SECTION SF 30 BLOCK 14 CONTINUATION PAGE

SUMMARY OF CHANGES

HALESIDE LEVEE LIME/FLY-ASH INJECTION
LEVEE MILE 121, SLOPE RESTORATION, HUXTABLE
LEE COUNTY, ARKANSAS

SKETCH "A"

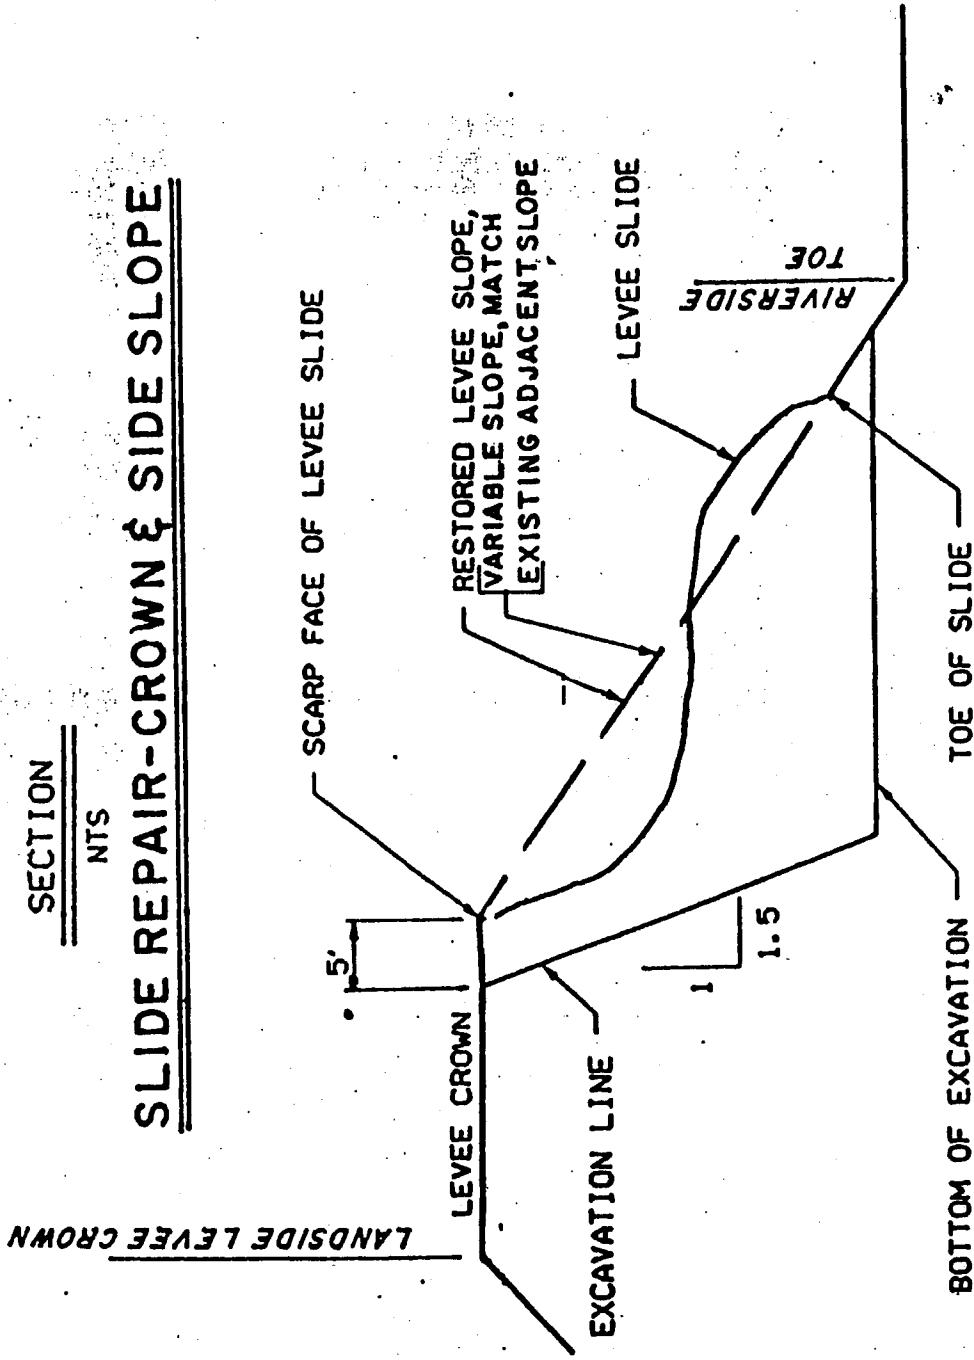
The Contractor will repair two existing slides near levee stations 121/2+00 and 121/4+00. Each slide is approximately 175 feet in length. The slides shall be repaired by excavating the slide to the dimensions indicated on the attached sketches "A" and "B" and placed according to the instructions contained herein. These slides shall be fully repaired prior to being injected with Lime/Fly-Ash slurry. All slides repairs will be turfed in accordance with Section 02935.

EXCAVATION SHALL BEGIN 5 FT. BEHIND SCARP FACE AND EXTEND DOWNWARD ON A 1V ON 1.5H SLOPE TO AN ELEVATION 1.0 FT. BELOW THE TOE OF THE LEVEE SLIDE.
